SOUTH CAROLINA BUILDING CODES STATEWIDE MODIFICATIONS INDEX

2015 INTERNATIONAL RESIDENTIAL CODE

**SOUTH CAROLINA MODIFICATIONS
TO THE 2015 EDITION OF THE
INTERNATIONAL RESIDENTIAL CODE**

FIGURE 307.2
MINIMUM FIXTURE CLEARANCES

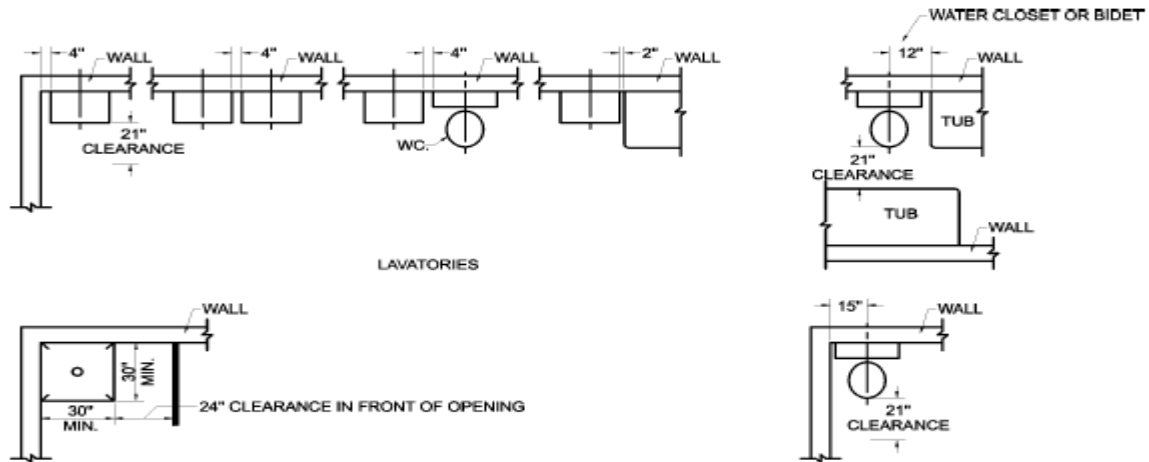
Modification Number: IRC 2015 08.

Figure: R307.1 Minimum Fixture Clearances.

Modification: Change the minimum dimension for the side clearance between bathtubs and water closets and bidets from 15 inches to 12 inches.

Reason: No valid reason exists to justify a minimum clearance of 15 inches.

Notes: Continued modification IRC 2003 05 and IRC 2006 06. The Figure number changed from 307.2 to 307.1 in the 2012 IRC.
